## Staff Report to the Zoning Administrator

Application Number: **05-0629**

**Project Description:** Proposal to demolish an existing **gas** station, to construct a replacement gas station and associated improvements, and to allow beer and wine sales.

**Re:** Design Reviewfor a new gas station at 200 Lee Road, Watsonville

LANDSCAPE SITE PLAN

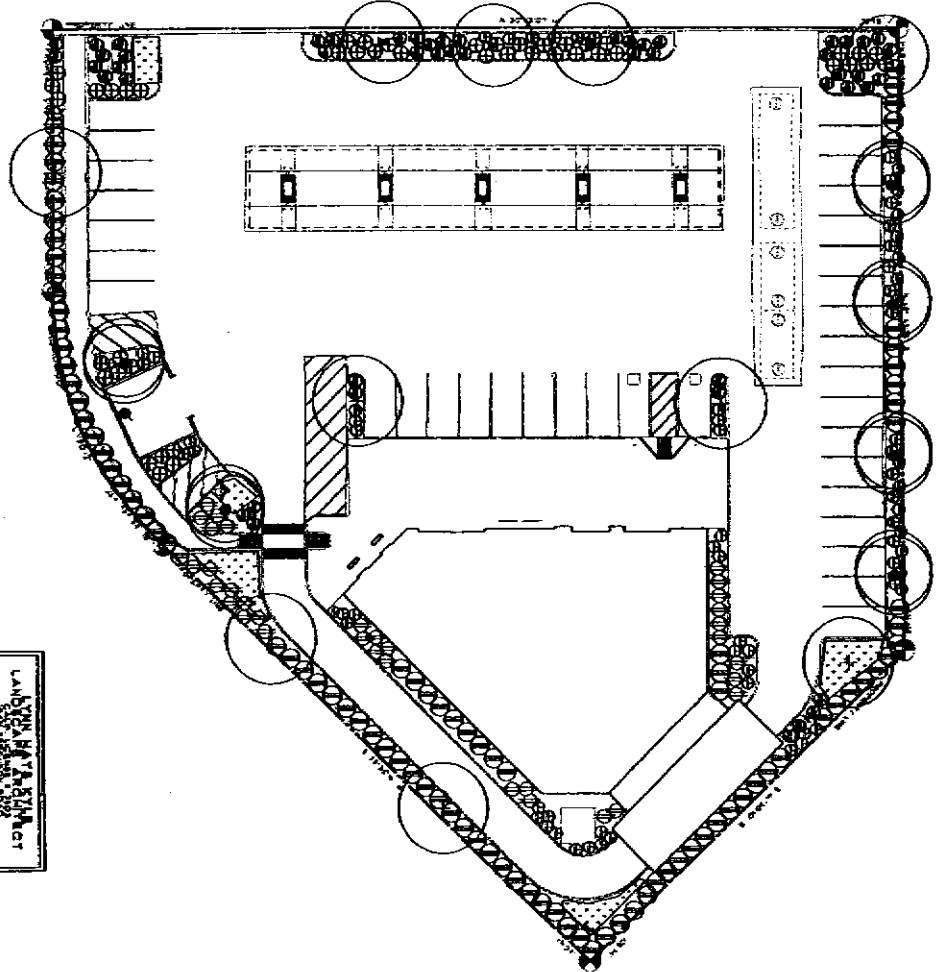
- *See Site Planning issues list for related comments,*
- *A five feet wide landscape (planted) strip on the south side is required. There is no rationale for a variance*
- *I would recommend substituting Dodonea viscosa instead of the Rhus.*

- Tree planting **should** be increased at the rear ~~of~~ the building.
- In some areas the trees would be better in groups of three
- The walkway ~~for~~ the disabled must be 4 feet wide throughout it's length.
- Planters or planting **ships** should occur in front of the building walls where **there** are no windows
- A patio should be designed for the restaurant. This should include a trellis and a low wall
- The Ceanothus **should** be planted at 3 feet on center.
- A spacing should be provided for the Lantana.
- Tree planting should include root barriers and a tube ~~for~~ a bubbler.
- Drip irrigation should be noted as the primary irrigation design type.
- Vines should be incorporated into the design adjacent to the building as appropriate.

===== REVIEW ON OCTOBER 20, 2005 BY GREG J MARTIN =====  
Show existing striping on Lee Road. The curb return for the driveway to the car wash is less than the 15 foot minimum required. Show an irrigation and landscaping plan. Show the existing and proposed site plans on separate sheets. Show the saw cut line a minimum of 2 feet from the lip of gutter. Clearly show right-of-way on both sides of Lee Road and easements. Show a typical section for Lee Road. Show a section for the parking lot and driveway on site.
